**EPA    Superfund  
Explanation of Significant Difference  
for the Record of Decision:**

**Apache Powder Co.,  
St. David, AZ  
4/16/1997**

**APACHE POWDER SUPERFUND SITE**  
**EXPLANATION OF SIGNIFICANT DIFFERENCES**  
**for the FINAL REMEDY RECORD OF DECISION**  
**April 1997**

**Figure 2**

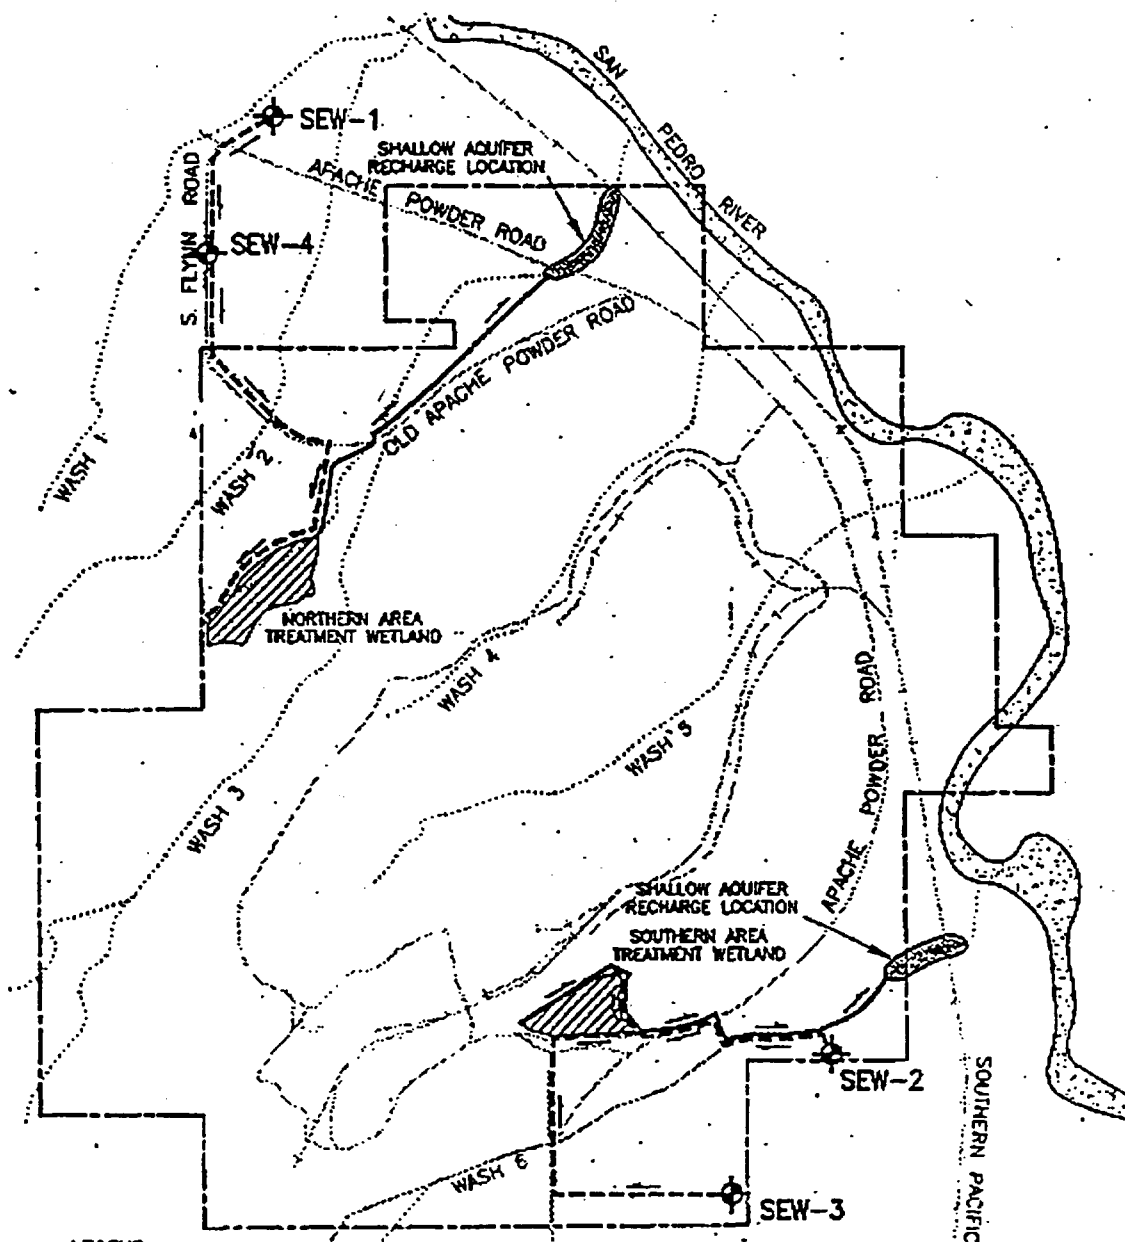
The ROD identified the use of a separate extraction system for pumping the perched groundwater into the brine concentrator. EPA now proposes to extract both the contaminated perched and shallow aquifer groundwater from one point in the southeast corner of the site. Due to ANP's process wastewaters no longer being released to the evaporation ponds as of April 1995, individual wells are drying up in the perched zone without any additional action being taken. New extraction wells in the perched zone may go dry or only be an efficient pumping location for a limited period of time. The cost of moving these extraction wells or reconfiguring piping would be high. Rather than designing a perched zone extraction system which will need constant changes, it should be more cost effective and technically feasible to extract the perched groundwater at the point it enters the shallow aquifer, an estimated 150 feet from the currently defined eastern boundary of the perched groundwater zone. Locating one extraction well and constructed wetlands treatment system in the southeast corner of the ANP facility will accomplish both source control of the perched groundwater zone and treatment of the geographic area of the plume with the second highest levels of nitrate contamination (Figure 2).

EPA, ADEQ, and ANP agree that the first set of constructed wetlands for treating the shallow aquifer should be located in a relatively "stagnant" portion of the shallow aquifer north of the ANP facility near the area where the concentration of nitrate in the shallow aquifer is the highest and where the groundwater circulation is low. This area is in the vicinity of shallow aquifer monitor wells MW-17 and MW-18 and is referred to as the "northern area". Siting the first set of constructed wetlands in this area will capture the nitrate-contaminated shallow aquifer plume as it migrates north. It also will maximize treatment in the area with the highest levels of nitrate where several residences are located and where there is the most potential for new residential development (Figure 2). This first set of wetlands would be constructed during the spring of 1997.

A second set of constructed wetlands will, if needed, be sited in the southeast corner of the ANP property to treat both the shallow aquifer in the southeast corner of the ANP property and water from the adjacent perched groundwater zone together (Figure 2). This area is another "stagnant" portion of the shallow aquifer in the vicinity of monitor wells MW-14 and MW-15 and is referred to as the "southern area". This area is where the perched and shallow aquifer converge, the concentrations of nitrate are very similar in both (unlike previously), and the perched zone was the original source for the contamination now found in the shallow aquifer in the southern area. Construction of the southern area treatment wetlands would begin approximately one year after the full-scale operation of the northern area treatment wetlands.

Figure 3. Map Showing Location of Shallow Aquifer Monitoring Wells and Proposed Shallow Aquifer Extraction Well Locations

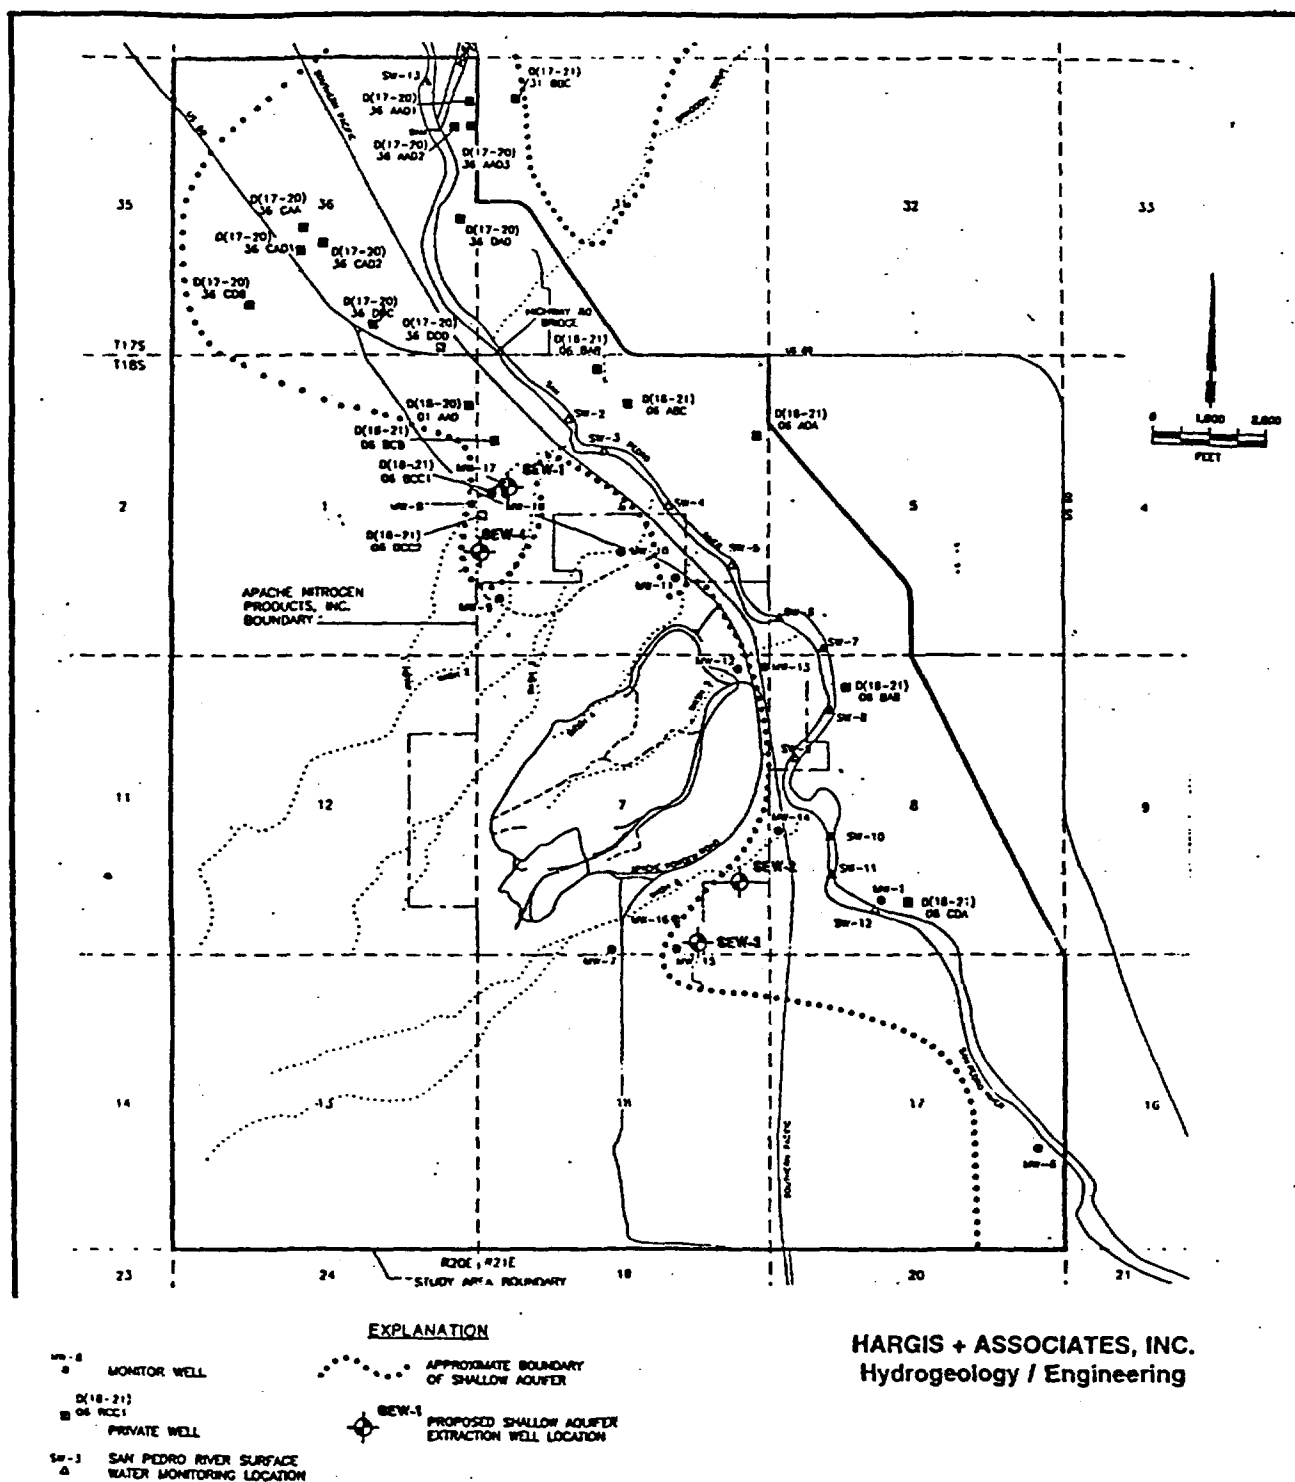
Remediation of this area involves treatment of the extracted groundwater from the shallow aquifer in two phases. Contaminated shallow aquifer groundwater would be extracted initially from one extraction well located in the vicinity of monitoring wells MW-17 and MW-18 and transported via a pipeline routed along private and county property until it crosses onto ANP property to the northern area wetlands treatment area. After the northern area wetlands have been operating an estimated four years, a review will be conducted to determine if an additional shallow aquifer extraction well and the corresponding pipeline would be required to completely capture the contamination in this area.

Remediation of the southern area also involves extraction of groundwater from the shallow aquifer in two phases. The first phase would extract groundwater in the vicinity of monitoring well MW-14. The second phase would extract groundwater in the vicinity of monitoring well MW-15. This would facilitate the overall cleanup of the shallow aquifer while cleaning up any contaminated perched groundwater draining into the shallow aquifer. During the first year or two of operation of the northern area extraction and wetlands treatment systems, monitoring data obtained would be collected to determine if additional monitoring wells or other design modifications are needed for the southern area extraction and wetlands treatment systems.
